02	26.10.2012	PNW	NWNG	Civil Column updated. Washing(F1G032) & Preparation (F1G042) rooms combined. In Buffer room(Washing(F1G032)/CP vessel provided. Utility room (F1G049) provided near to Class B Change room entry area. At back (F1G035) removed and Dynamic pass box provided. Dynamic pass box provided between Corridor(F1G010) to Air lock(F1G031).		
01	22.10.2012	PNW	NWNG	Layout updated as per client's comments at the date: 19.12.11 & 20.12.11. Internal layout modified to accommodate the South West side area.		
Rev.	Date	Changed	Checked	Kind of revision	No. of Prints	Date Issued to
Project: HLL LIFE CARE LIMITED PASTEUR INSTITUTE OF INDIA, COONNOR						
Project No.: 110831				Project Name: nne pharmaplan		
Location: COONNOR				Client Name: nne Pharmaplan India Limited		
Description: PROPOSED CONCEPTUAL LAYOUT OF FORMULATION BLOCK GROUND FLOOR				Address: #14, Achiah Street Layout, Bangalore - 560 080., INDIA.

Drawn: 22.12.2011		Date: 22.12.2011		Name: PNW		
Checked: 23.12.2011		Date: 23.12.2011		Name: NABP/NWNG		
Scale: 1:150		Units: mm		Size: A2		
Drawing no: NP/110831/LV(GEN)/F-01		Rev: 06		Rev: 06

GROUND FLOOR @ 77.50 M LVL.

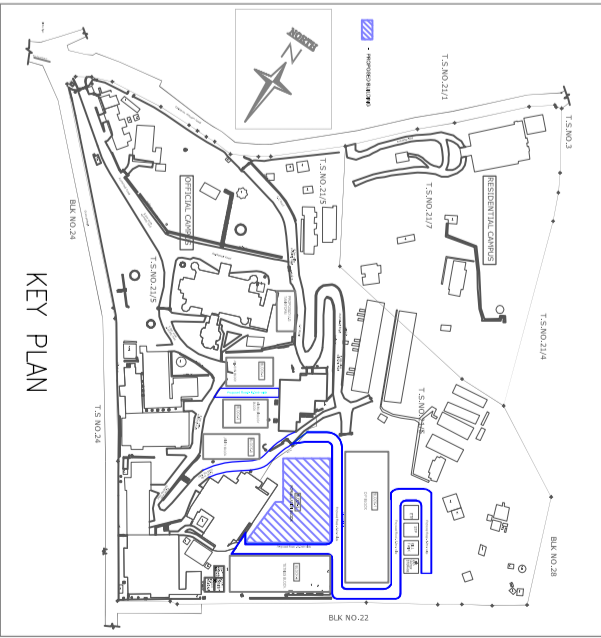
06	13.08.2013	LNW	SLW	Val collection room & corridor area modified based on client comment.		
05	29.07.2013	SAPL	NWNG	Post and pre inspection Cold Rooms (F1G029 & F1G030) Classification has been changed from Class E to Unidirectional area in Gd Preparation room provided. Zoned of CIP & 1 no of SIP Circulation unit provided. In Buffer pre-room CIP Station 250L change to 150L. Revised as per the MOP dated on 13.08.2013.		
04	17.05.2013	RNR	PMAY	Dynamic class box 600x600x900mm changed to 900x1200x1500mm between room F1G048 to F1G037. Spare Room(F1G032) has changed to F1G048. Change room (F1G049) buffer (F1G049) Change room (F1G049) provided near to Class B Change room entry area. wall autoclave & DHS technical area covering wall panel on both sides are not shown. Washing room(F1G032) and preparation room (F1G033A).		
03	04.01.2013	PNW	NABP	Wash area changed as per advised of NIA during CRI visit.
